Commission of Architectural Review

1. COA-186709-2026	Final Review	Meeting Date: 7/28/2026
Applicant/Petitioner	Rachel Zeeve	
Project Description	Paint mural on previously painted building	
Project Location		
Address: 2405 Jefferson Ave		
Historic District: Church Hill North		
High-Level Details: The applicant proposes a community-designed mural on the approximately 20-foot-high by 50-foot-long East Leigh Street elevation of a one-story brick building circa 1941. Local muralist Hamilton Glass will develop the final design through focus groups and sketches with youth served by Streamline Wellness Center. While the final design of the mural is yet to be created, the mural's themes will be centered around a youth-centered mural that celebrate resilience, family health, community wellness, and hope while reflecting the voices and creativity of young people.		
Staff Recommendation	Approval, with Conditions	
Staff Contact	Kevin Costanzo, Kevin.Costanzo@RVA.gov, (804)646-6335

Figure 1. Existing unpainted East Leigh Street elevation (proposed mural location)

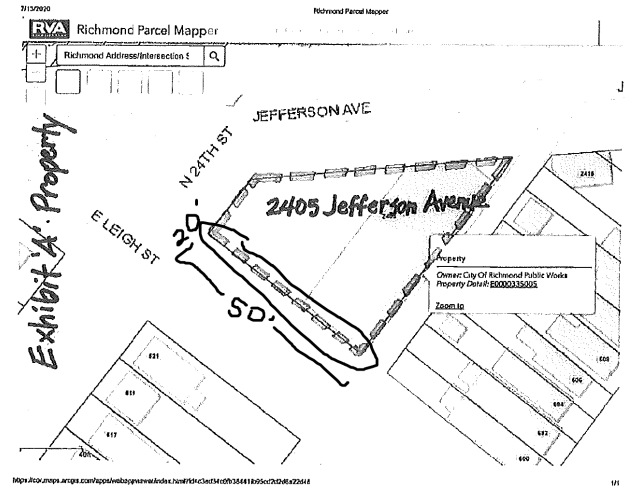
Guideline Reference	Reference Text	Analysis
Paint, p. 63, #1	<i>Do not paint historic brick or stone masonry that has not previously been painted.</i>	The applicant indicates that the mural will be installed on the East Leigh Street elevation, which is unpainted brick. Painting the mural directly on this wall would be inconsistent with the guideline. <u>Staff recommends that the mural be installed on a removable panel system.</u> <i>Staff encourages the applicant to consider a previously painted, non-primary elevation, where direct painting may be considered only within the limits of the existing painted masonry.</i>
Mural Guidelines, p. 75, #1	<i>In general, murals should be painted on removable material, not directly on a building wall. Murals should be installed on framing that allows water to weep between the mural and the wall. Attachments should not irrevocably damage the building. Painting directly onto the walls of a non-contributing building will be considered by the Commission on a case-by-case basis. Adding a mural to a previously-painted, non-primary elevation of a contributing building will be considered on a case-by-case basis.</i>	<u>Staff recommends that the panel system be installed in a way that does as little damage to historic material as possible, and allows for ventilation between the panel and brick wall surface.</u>

Previous Reviews	COA-188409-2026 (Signage Admin Approval)	
Staff Recommendations	- Mural be installed on a removable panel system. - Panel system be installed in a way that does as little damage to historic material as possible, and allows for ventilation between the panel and brick wall surface. - Mural not use dayglow, luminescent, or reflective paint. - Final paint type and general color scheme be submitted to staff for review and approval. - The applicant coordinate with the City of Richmond Public Art Commission and Planning Commission on any subsequent reviews needed prior to starting work. <i>Staff encourages the applicant to consider a previously painted, non-primary elevation, where direct painting may be considered only within the limits of the existing painted masonry.</i>
